NEW MEXICO OIL CONSERVATION DIVISION
 - Engineering Bureau -
 1220 South St. Francis Drive, Santa Fe, NM 87505

APPLICATION FOR AUTHORIZATION TO INJECT

WELL NAME & NUMBER: Fee MA B #6

Mack Energy Corporation respectfully requests an administrative approval without notice and hearing for the Fee MA B #6 & #7 application to convert into SWD wells.

Fee MA B #6

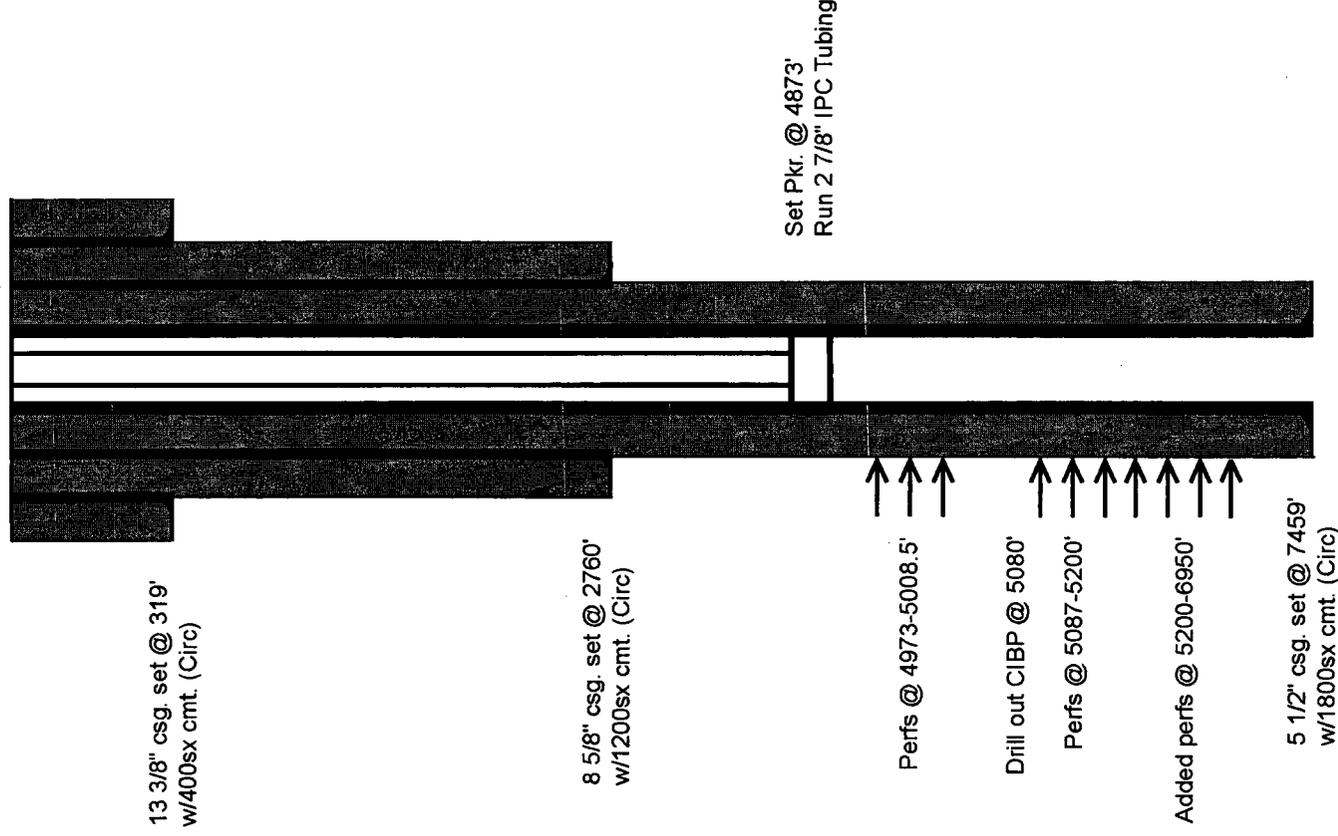
- 1) proof of notice to Southwestern Energy Production Company since they operate a well within 1/2 mile of both of your proposed injectors.
- 2) Clearly marked "before conversion" and "after conversion" wellbore diagrams
- 3) Have your geologist send a list of the depths of all formation tops within at least one of these wells especially the top and bottom of the Delaware and the Bone Spring.
- 4) Let me know if either of these wells had a DV tool installed in the casing, the depth of the tool, and if cement circulated below and above the tool.
- 5) Send all formation name(s) of produced waters to be injected into these wells.
- 6) Send water analysis on all waters from formations that are not identical to the injection interval(s).

1. Proof of notice attached.
2. Diagrams attached.
3. Fee MA-B #7: Top San Andres: 4417' Base San Andres: 5930' Top Upper Bone Springs Carbonate: 5930' Base Upper Bone Springs Carbonate: 7580' Top 1st Bone Spring Sand: 7580' No Delaware
Fee MA-B #6: Top San Andres: 4764' Base San Andres: 4940' Top Delaware: 4940' Base Delaware: 5210' Top Upper Bone Springs Carbonate: 6060' Base Upper Bone Springs Carbonate: 7280' Top 1st Bone Springs Sand: 7280
4. Fee MA B #6 No DV Tool
Fee MA B #7 DV Tool @ 5838' Cement 1280 sx, circulated 50 sx. Drop plug cement w/4000 sx, circulated 275 sx.
5. Maljamar GB SA, Corbin Abo, Corbin Delaware, Corbin Bone Spring
6. Analysis attached.
